RE: ECOSST REVIEW - V-FEE MENDHAM APARTMENTS LLC APPLICATION

**RE: V-FEE MENDHAM APARTMENTS LLC DEVELOPMENT APPLICATION  
84-90 MAIN STREET  
BLOCK 801, LOT 20  
MENDHAM BOROUGH, MORRIS COUNTY**

As you requested, One Water Consulting LLC (One Water) has reviewed the above-referenced application on behalf of the Borough of Mendham Environmental Commission, Open Space, and Shade Tree (ECOSST) Committee. V-Fee Mendham Apartments, LLC has proposed a multi-family residential development on Block 801, Lot 20 in the Borough of Mendham, Morris County, New Jersey. I have prepared this letter to provide comments related to the overall application.

# StreamStats Report

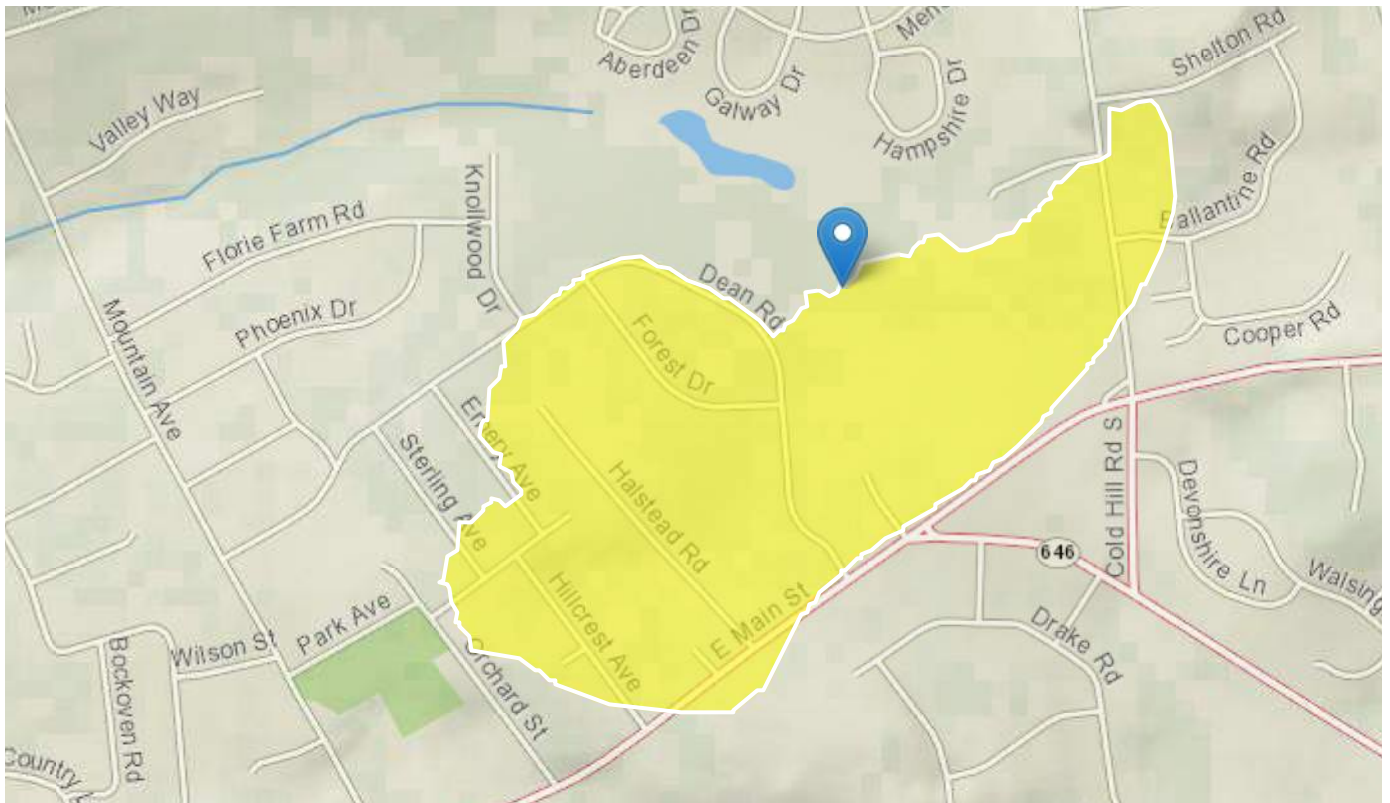
- b. We have run USGS StreamStats as a point of reference for the total drainage area to the stream at the site. The StreamStats report is provided as Attachment B which shows a drainage area of 173 acres, which is more than double the area of 75 acres presented in the Flood Hazard Area Study.
